## ADDENDUM #1

**Project:** Ogden-Hinkley Airport  
Remodel

**Project Number:** 2021-10

**Date:** 11.21.23

GI002

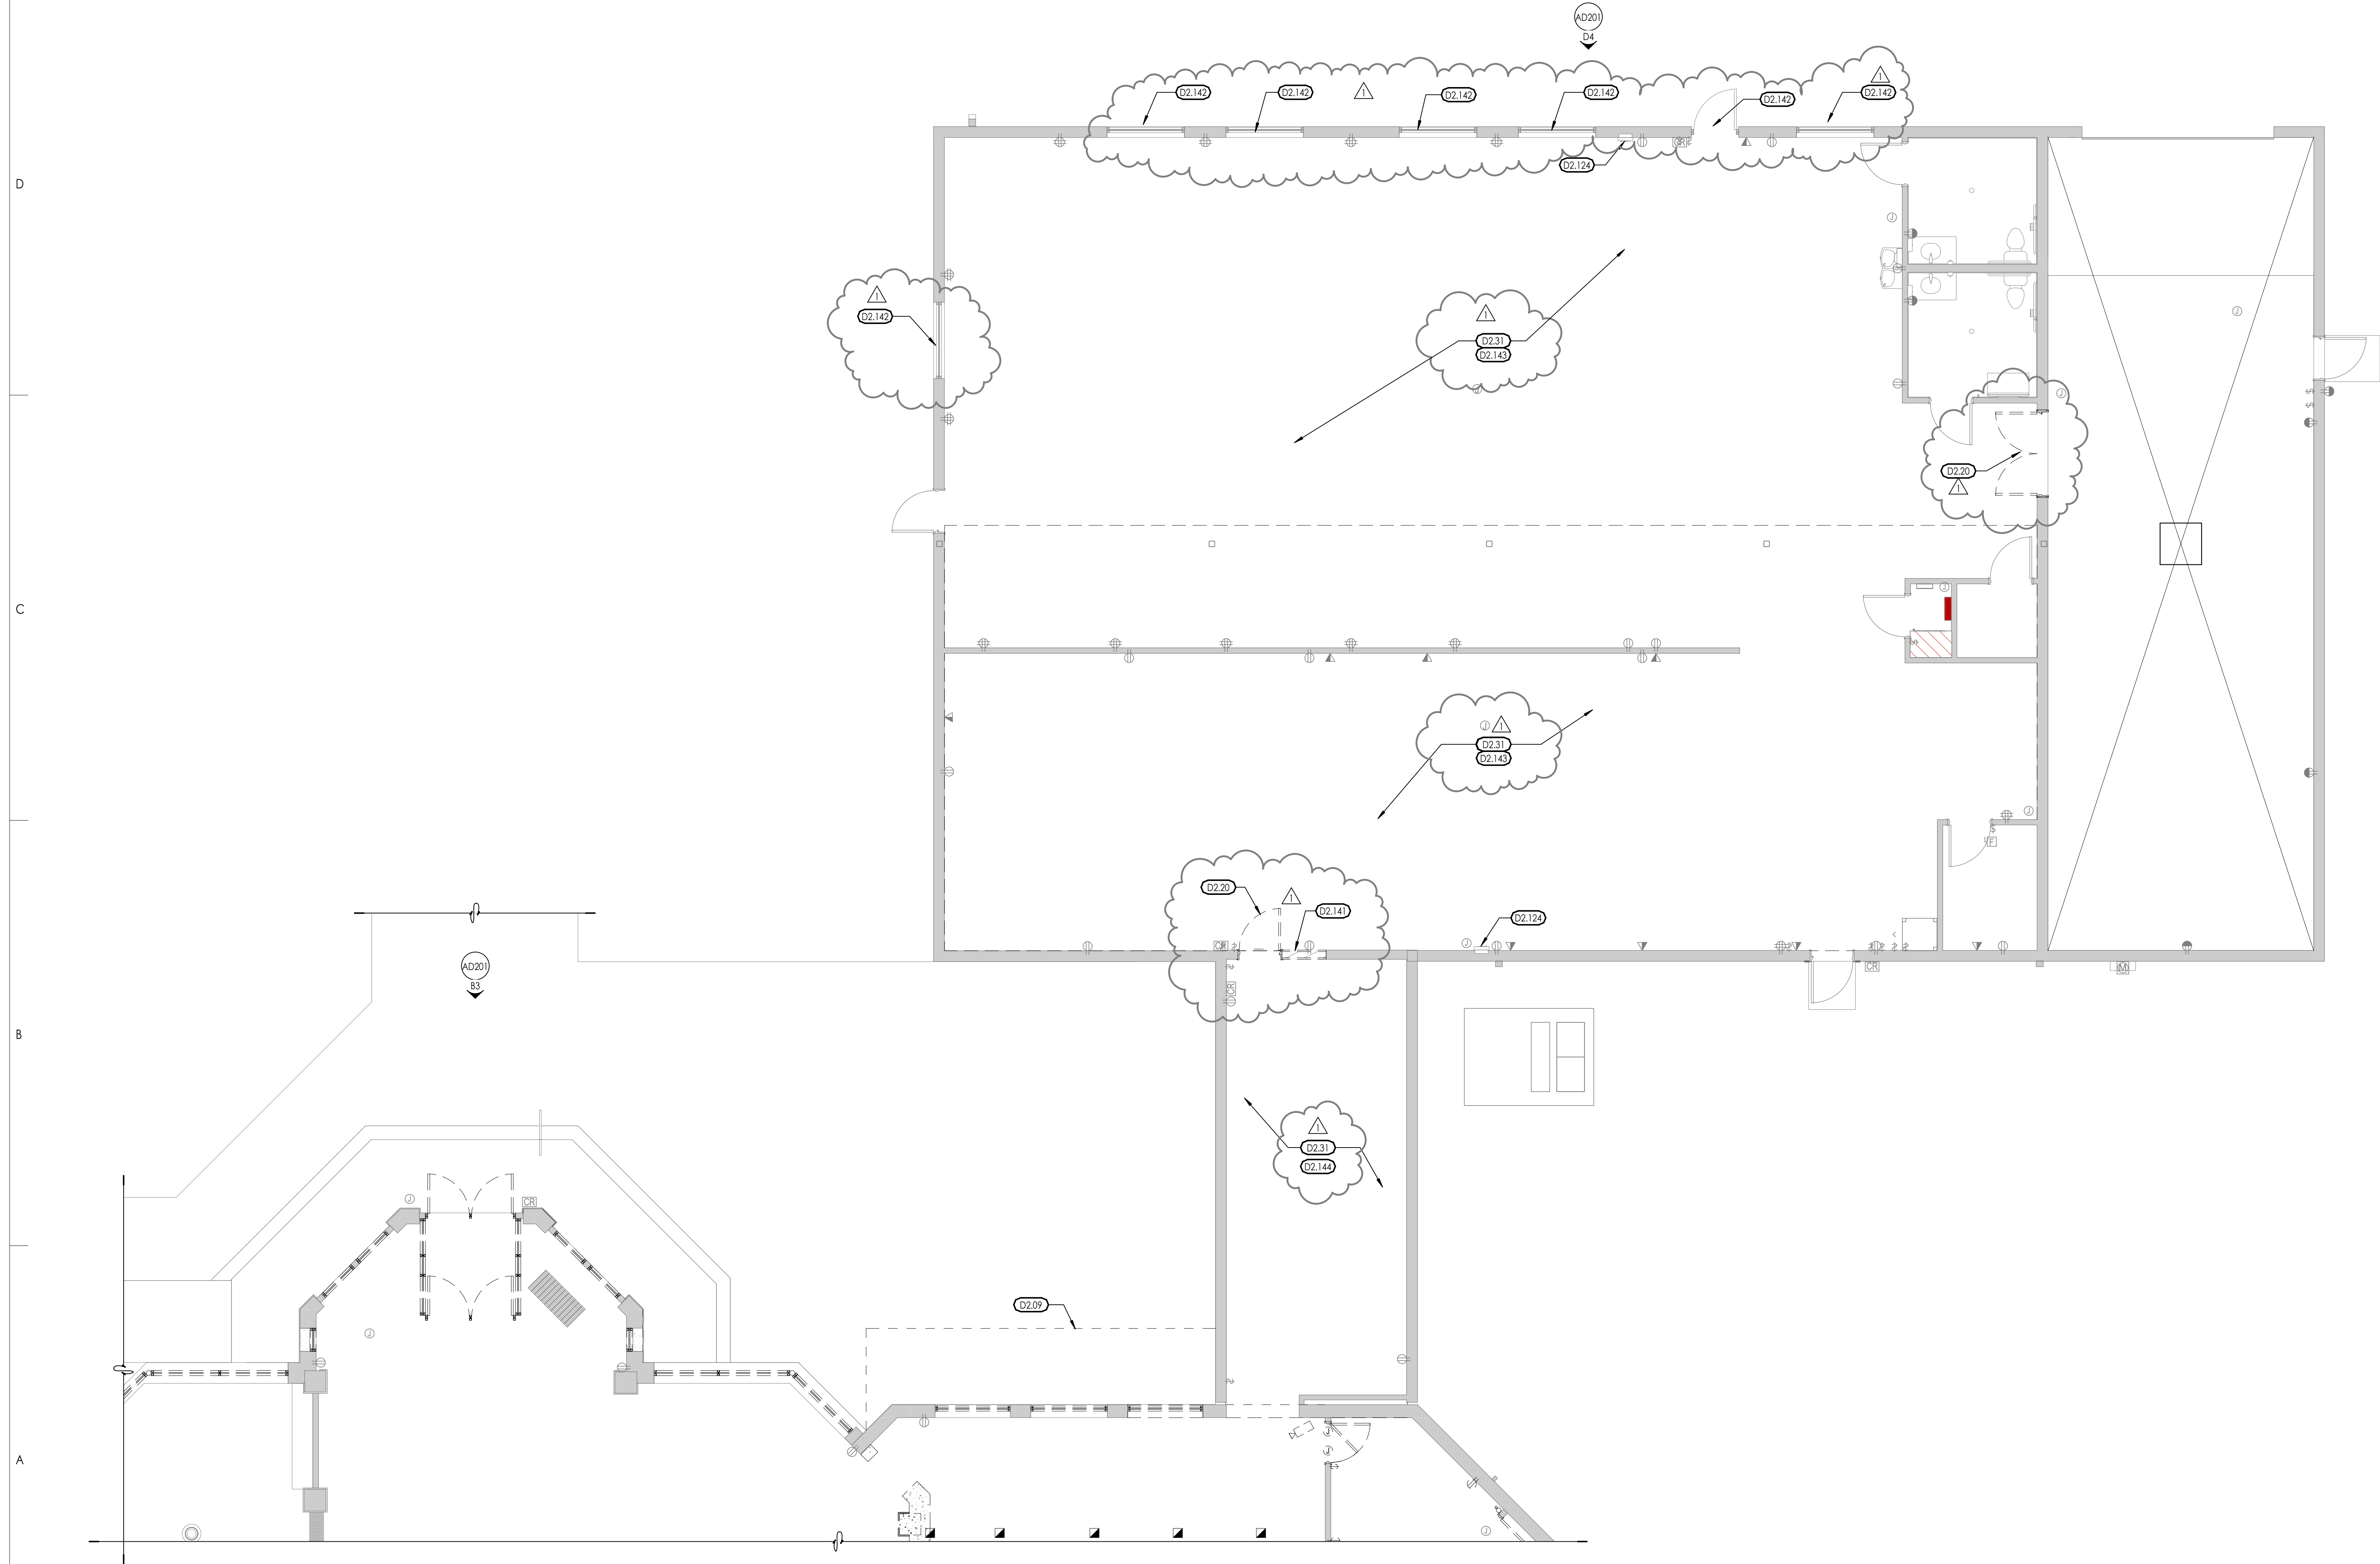
1. Drawing GI002:
  - A. Alternate #1, for removing the existing concrete column, is omitted. The work is to be included in the project.
2. Drawing AD102:

AD102

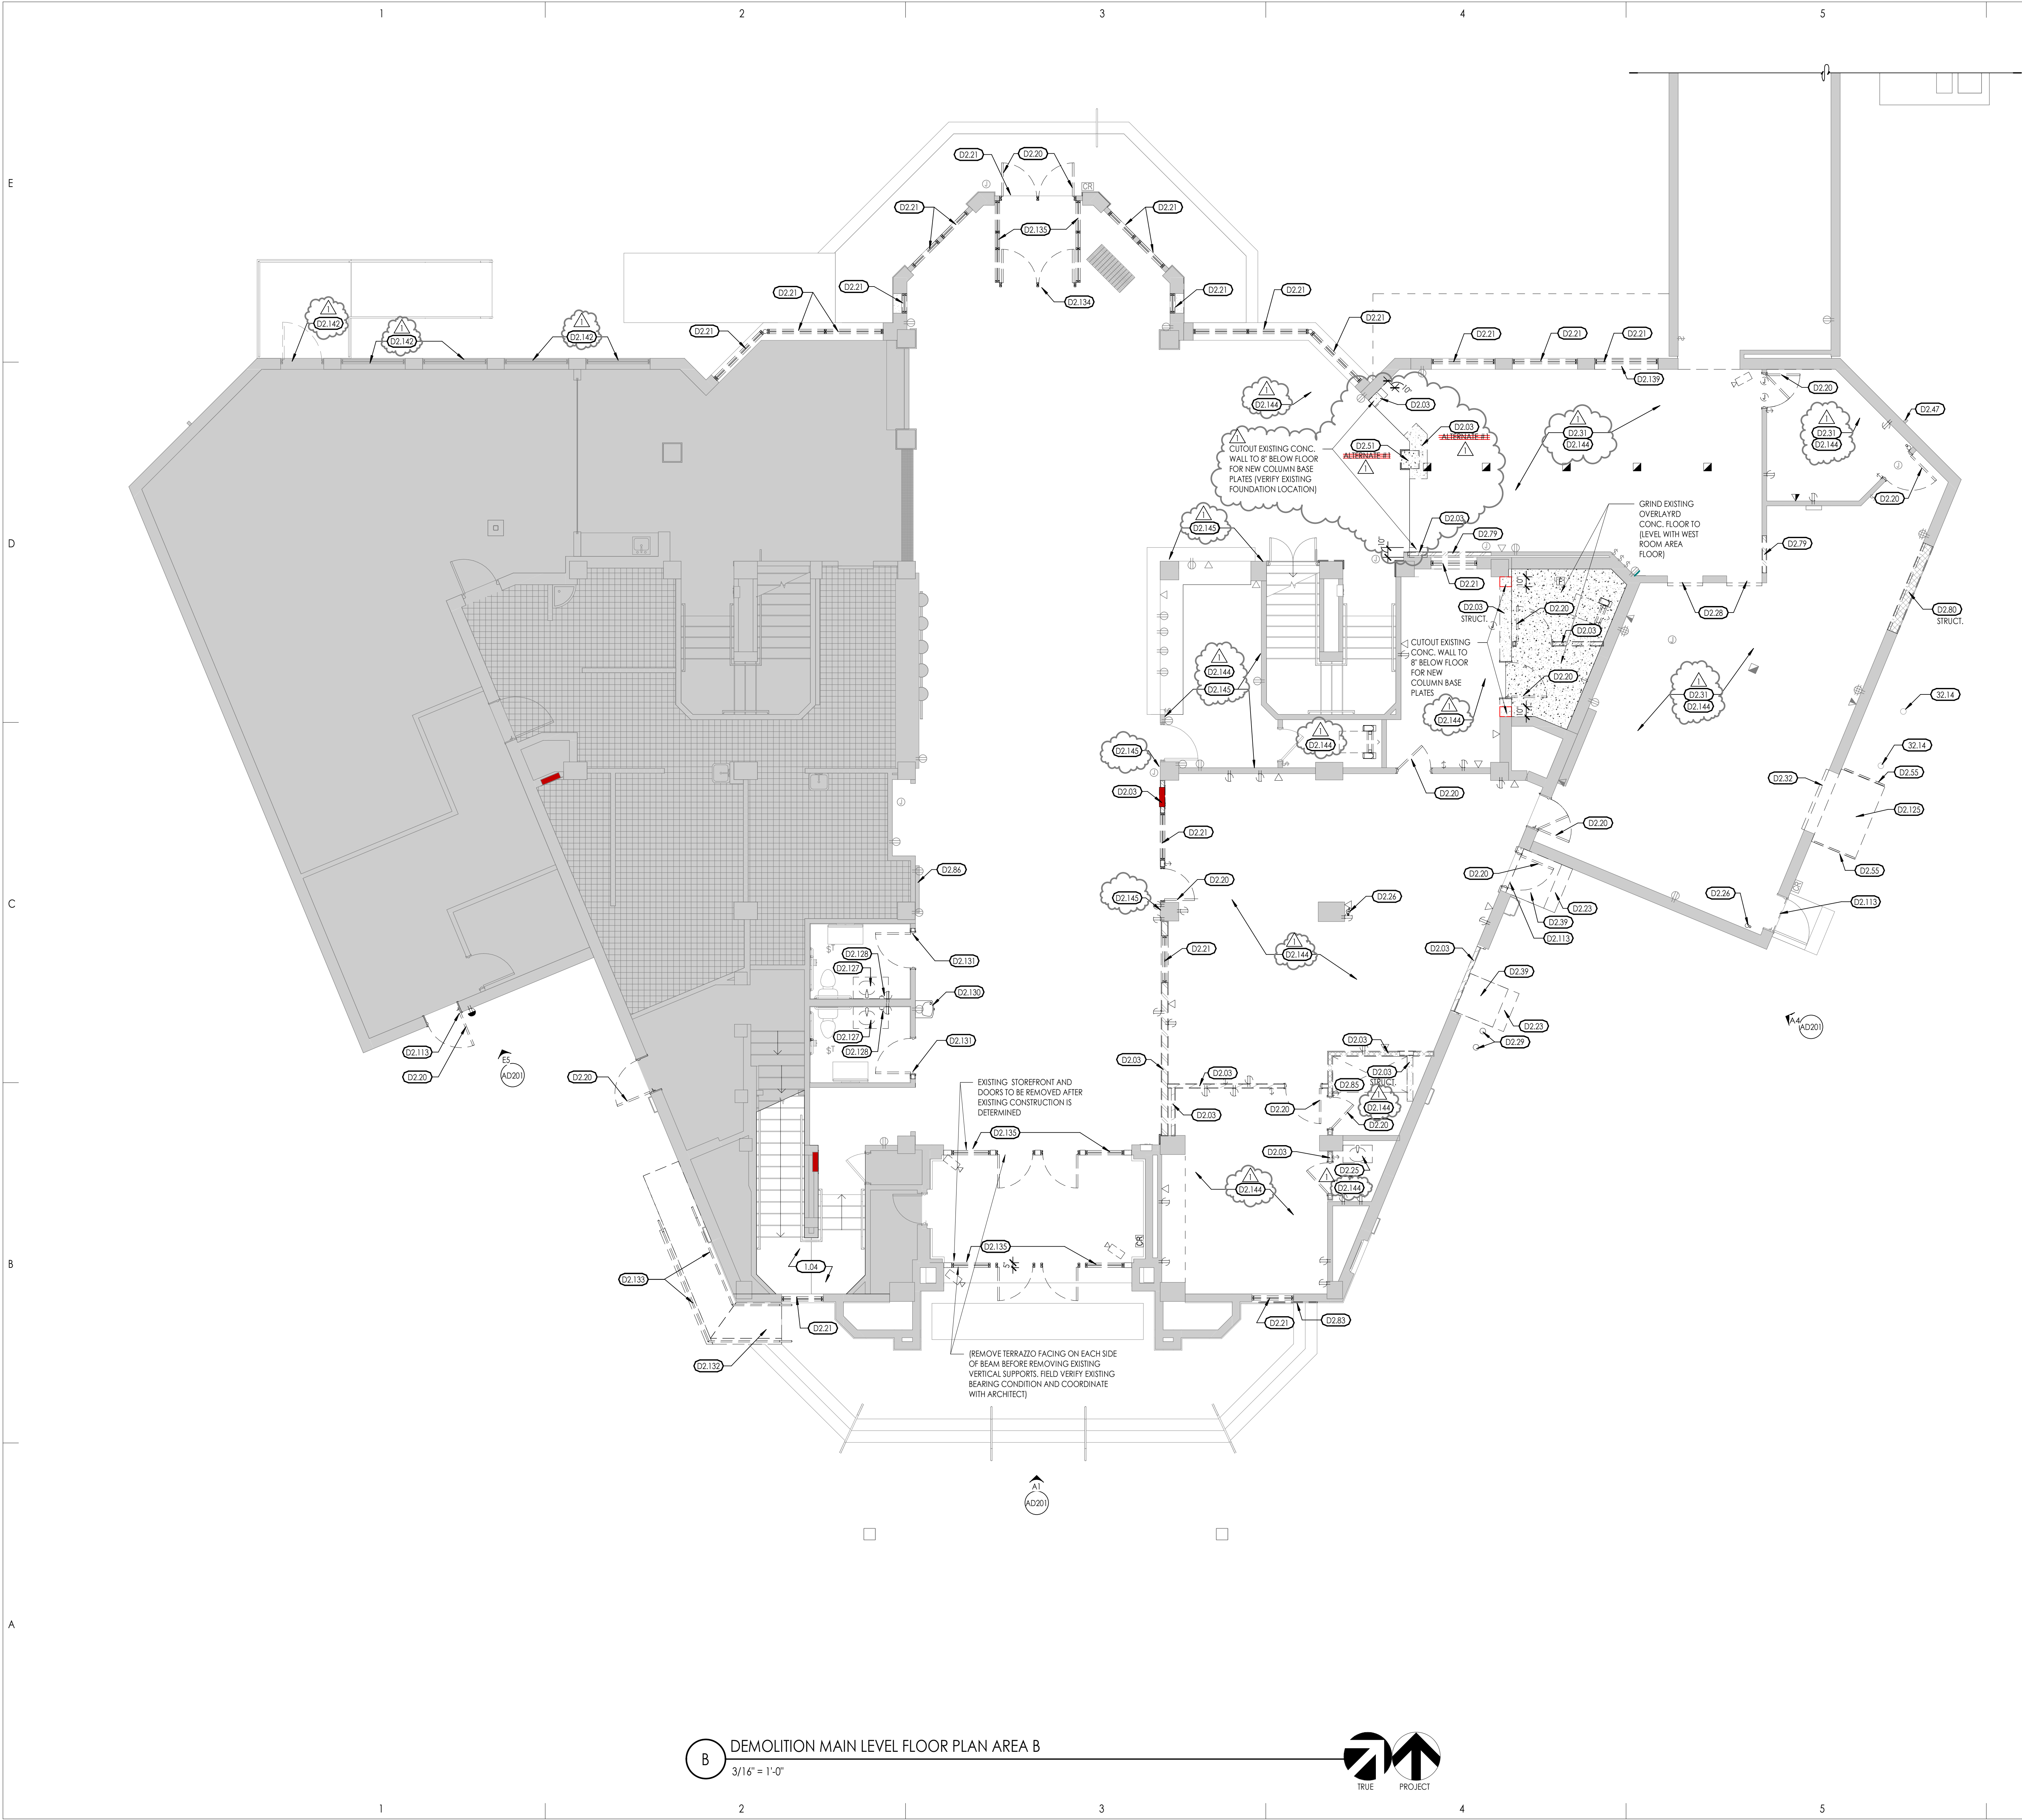
- A. Carpet indicated to be removed, stored on pallets and returned to Owner for storage. Keyed note 'D2.31' is added.
  - B. Rubber based indicated to remain in existing rooms indicated on drawing. Keyed Note: 'D2.143' is added.

- C. Rubber based indicated to be removed in the sloping floor concourse between buildings. Keyed Note: 'D2.144' is added.
  - D. The two door and frame locations indicated being removed.

- E. Cutout new door opening for double door installation. Shore bearing wall for new wall framing. Refer to Structural.
  - F. Some exterior windows are indicated to have the film removed from the glazing.

**AD103**

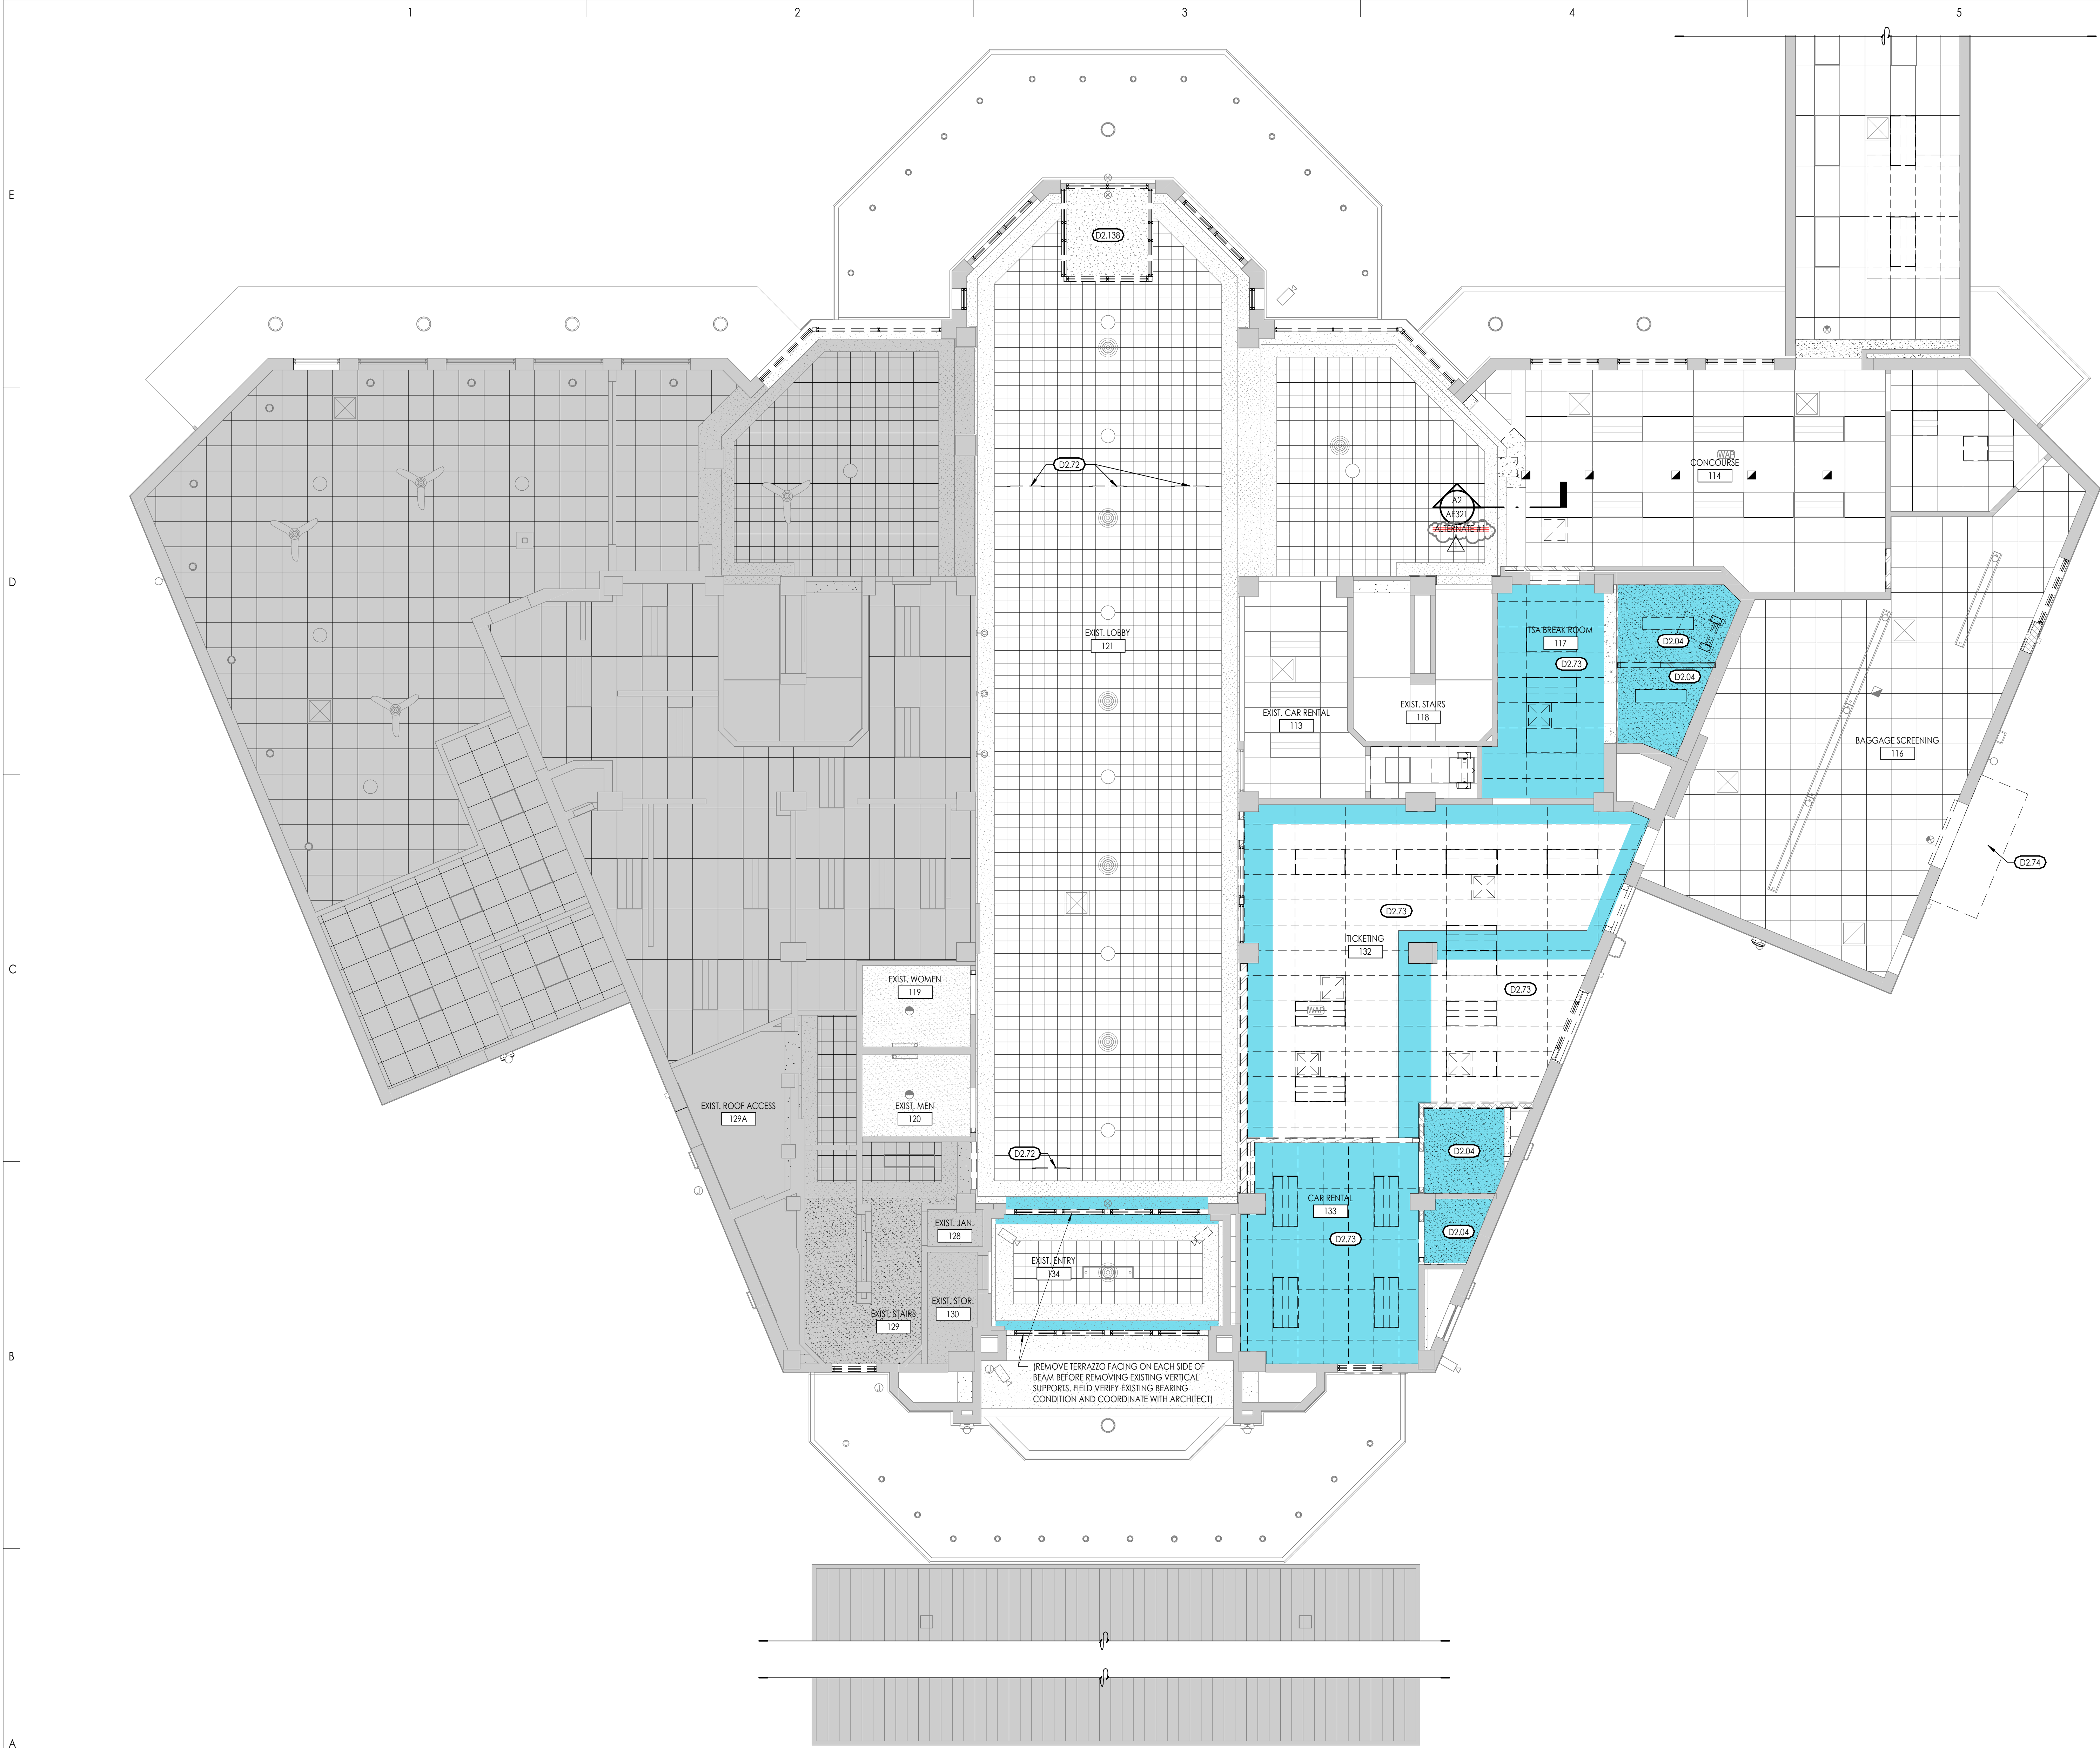
3. Drawing AD103:
  - A. Carpet indicated to be removed in rooms indicated, stored on pallets, and returned to Owner for storage. Keyed note: 'D2.31' is added.

- B. Rubber based indicated to be removed in the sloping floor concourse between buildings. Keyed Note: 'D2.144' is added.
  - C. Alternate #1 for removing the existing concrete column is omitted. The work is to be included in the project.

- D. Existing wall covering is to be removed. Keyed Note: D2.145' is added around the existing Car Rental area.
  - E. Some exterior windows are indicated to have the film removed from the glazing.
